Access Compliance Report

Public Rights-of-Way

Intersection ID: 50593	Main Street: LUSTERLEAF HOLLY RD	Cross Street: GRAY WILLOW RD	Location: SW
ADA ID: C235C1A4742B	Ramp Type: Perp	Initial Pass/Fail: Fail	Overall Compliance: No
Severity Score: 33.75			
Codes/Mitigation Info/Possible Solution		Field Measurements/Component Compliance

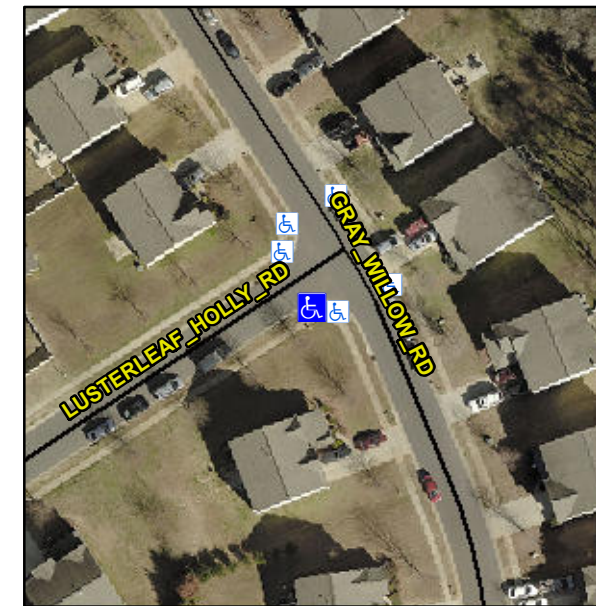
Not Found, R304.5.1, R304.2.2

Compliance	Description	Data	Compliance	Description	Data
N/A	Ramp Length (in)	47.0	No	Ramp Slope (%)	12.6
No	Ramp Width (in)	47.5	Yes	Ramp XSlope (%)	0.4
N/A	Flare Type LT	N/A	N/A	Flare Type RT	N/A
N/A	Flare Slope LT (%)	N/A	N/A	Flare Slope RT (%)	N/A
N/A	Flare Traversable LT?	N/A	N/A	Flare Traversable RT?	N/A
N/A	Landing Length (in)	N/A	N/A	DWS Provided?	N/A
N/A	Landing Width (in)	N/A	N/A	DWS Contrast?	N/A
N/A	Landing Slope (%)	N/A	N/A	DWS Length (in)	N/A
N/A	Landing X Slope (%)	N/A	N/A	DWS Full Width?	N/A
N/A	Landing Curb? (Y/N)	N/A	N/A	DWS Offset (in)	N/A
N/A	Shared Landing?	N/A			
N/A	Gutter Ponding?	N/A	N/A	Gutter Slope (%)	N/A
N/A	Gutter Lip Ht (in)	N/A	N/A	Gutter X Slope (%)	N/A
N/A	Painted X Walk1?	No	N/A	Painted X Walk2?	N/A
	X Walk 1 Direction	To N		X Walk 2 Direction	N/A
N/A	X Walk 1 Width (in)	N/A	N/A	X Walk 2 Width (in)	N/A
	X Walk 1 Slope (%)	0.4		X Walk 2 Slope (%)	N/A
	X Walk 1 X Slope (%)	1.5		X Walk 2 X Slope (%)	N/A

Remove & Replace Entire Ramp.
